E/ECE/324
E/ECE/TRANS/505 } Add.1/Rev.4/Amend.3

Addendum 1: Regulation No. 1

Revision 4 - Amendment 3

UNIFORM PROVISIONS CONCERNING THE APPROVAL OF MOTOR VEHICLE HEADLAMPS EMITTING AN ASYMMETRICAL PASSING BEAM AND/OR A DRIVING BEAM AND EQUIPPED WITH FILAMENT LAMPS OF CATEGORIES R_2 AND/OR HS1

Figure 1

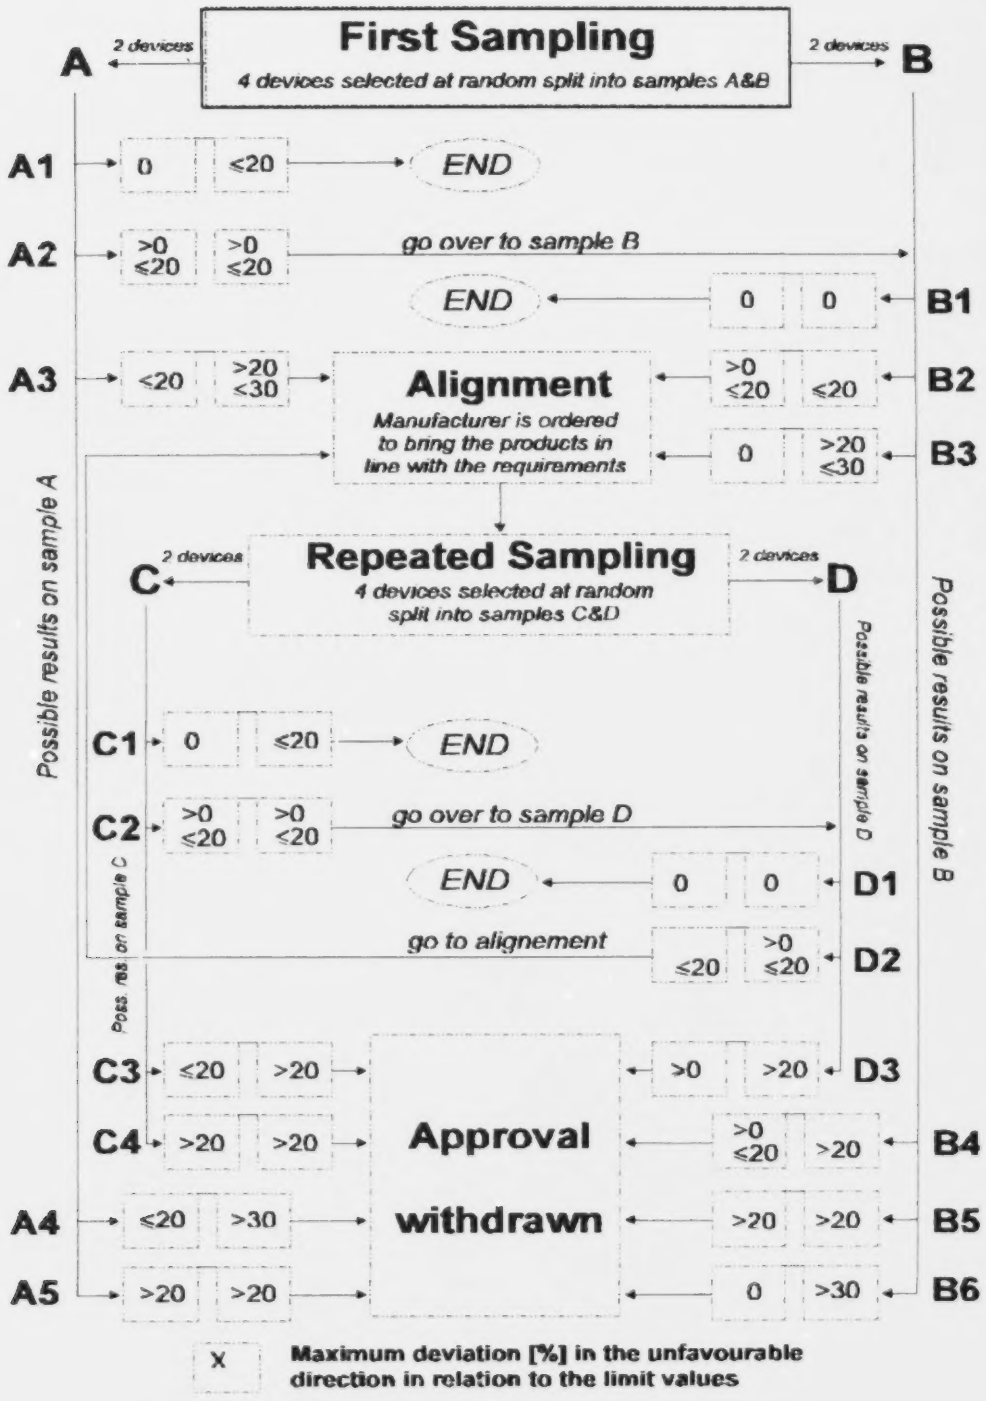
Add a new Annex 8, to read:

2. FIRST SAMPLING

In the first sampling four headlamps are selected at random. The first sample of two is marked A, the second sample of two is marked B.

2.1.1. Following the sampling procedure shown in Figure 1 of this annex the conformity of mass-produced headlamps shall not be contested if the deviation of the measured values of the headlamps in the unfavourable directions are:

2.2.1. Following the sampling procedure shown in Figure 1 of this annex the conformity of mass-produced headlamps shall be contested and the manufacturer requested to make his production meet the requirements (alignment) if the deviations of the measured values of the headlamps are:

Conformity shall be contested and paragraph 10 applied if, following the sampling procedure in Figure 1 of this annex, the deviations of the measured values of the headlamps are:

In the cases of A3, B2, B3 a repeated sampling, third sample C of two headlamps and fourth sample D of two headlamps, selected from stock manufactured after alignment, is necessary within two months' time after the notification.

3.1.1. Following the sampling procedure shown in Figure 1 of this annex the conformity of mass-produced headlamps shall not be contested if the deviations of the measured values of the headlamps are:

3.2.1. Following the sampling procedure shown in Figure 1 of this annex the conformity of mass-produced headlamps shall be contested and the manufacturer requested to make his production meet the requirements (alignment) if the deviations of the measured values of the headlamps are:

Conformity shall be contested and paragraph 10 applied if, following the sampling procedure in Figure 1 of this annex, the deviations of the measured values of the headlamps are:
